September 19, 2018

Urgent: Important Safety Update
AFX[®] Endovascular AAA System

Figure 4: Ensure Guidewire Is Not Caught Behind Stent Strut

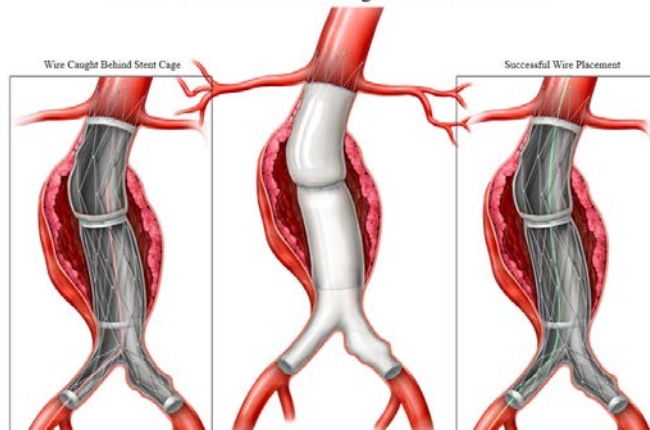
1. Refer to institutional protocols relating to anesthesia, anticoagulation and monitoring of vital signs.
2. Position patient on imaging table allowing fluoroscopic visualization from the aortic arch to the femoral bifurcations.
3. Gain luminal access through the femoral arteries.
4. Establish adequate proximal and distal vascular control of the surgically exposed femoral artery, as needed.
5. Following the manufacturer’s instructions for use, advance a flexible “J-tip” guidewire, pigtail catheter, or acceptable equivalent, into the vasculature under fluoroscopy.
 - NOTE: Proper device choice may limit the likelihood of tracking behind a stent strut. Reference **Figure 4**.

Figure 5: Use of a Balloon to Confirm Correct Placement of Guidewire

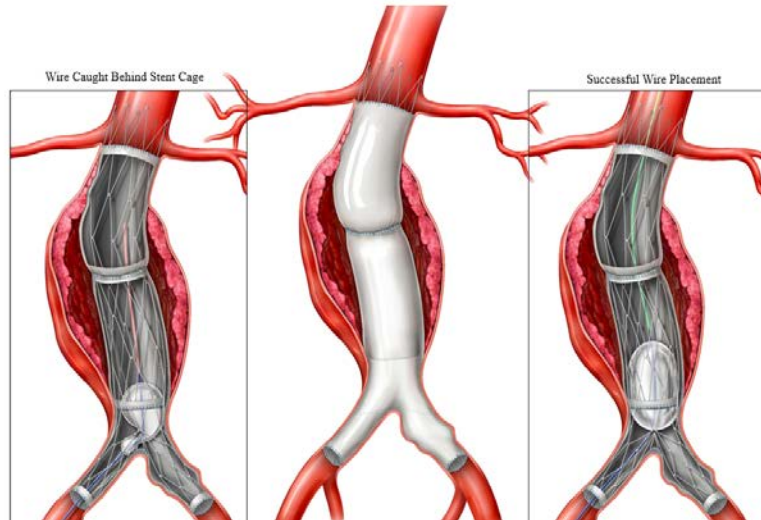
6. Once the flexible “J-tip” guidewire or pigtail catheter reaches above the existing AFX device, slowly advance an occlusion balloon or PTA balloon over the wire and under fluoroscopy. Slowly inflate, per the manufacturer’s instructions, until the balloon has been fully shaped or formed. It is recommended to use a 12mm diameter PTA balloon or an occlusion balloon that is partially inflated to ensure devices are not behind a stent strut.
 - Advance and retract the balloon catheter up and down the entire length of the existing AFX device to ensure there is proper luminal wire access.
 - NOTE: Balloon kinking during inflation or enlargement of a section of the stent cage may be a signal of a potential wire placed behind a stent strut. Reference **Figure 5**.
